# Access Compliance Report

## Public Rights-of-Way

Intersection ID: N/A	Main Street: GROVER_RD	Cross Street: N/A	Location: NE
ADA ID: 812F5190B9B6	Ramp Type: PerpDiag	Initial Pass/Fail: Fail	Overall Compliance: No
		Severity Score: 12.5

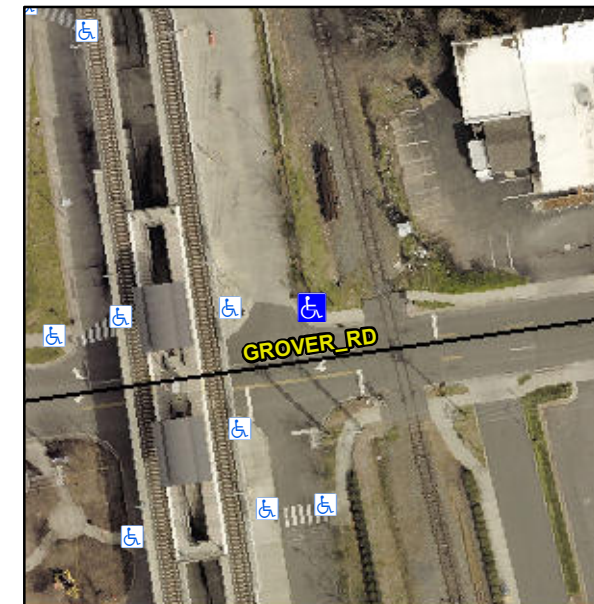
**Not Found, R304.5.3**

Compliance	Description	Data	Compliance	Description	Data
N/A	Ramp Length (in)	39.0	Yes	Ramp Slope (%)	6.4
Yes	Ramp Width (in)	48.0	No	Ramp XSlope (%)	5.1
N/A	Flare Type LT	N/A	N/A	Flare Type RT	N/A
N/A	Flare Slope LT (%)	N/A	N/A	Flare Slope RT (%)	N/A
N/A	Flare Traversable LT?	N/A	N/A	Flare Traversable RT?	N/A
N/A	Landing Length (in)	N/A	N/A	DWS Provided?	N/A
N/A	Landing Width (in)	N/A	N/A	DWS Contrast?	N/A
N/A	Landing Slope (%)	N/A	N/A	DWS Length (in)	N/A
N/A	Landing X Slope (%)	N/A	N/A	DWS Full Width?	N/A
N/A	Landing Curb? (Y/N)	N/A	N/A	DWS Offset (in)	N/A
N/A	Shared Landing?	N/A			
N/A	Gutter Ponding?	N/A	N/A	Gutter Slope (%)	N/A
N/A	Gutter Lip Ht (in)	N/A	N/A	Gutter X Slope (%)	N/A
N/A	Painted X Walk1?	No	N/A	Painted X Walk2?	No
	X Walk 1 Direction	To W		X Walk 2 Direction	To S
N/A	X Walk 1 Width (in)	N/A	N/A	X Walk 2 Width (in)	N/A
	X Walk 1 Slope (%)	5.5		X Walk 2 Slope (%)	2.8
	X Walk 1 X Slope (%)	2.1		X Walk 2 X Slope (%)	6.2

**Remove & Replace Curb Ramp With Two New Directional Ramps or Equivalent.**
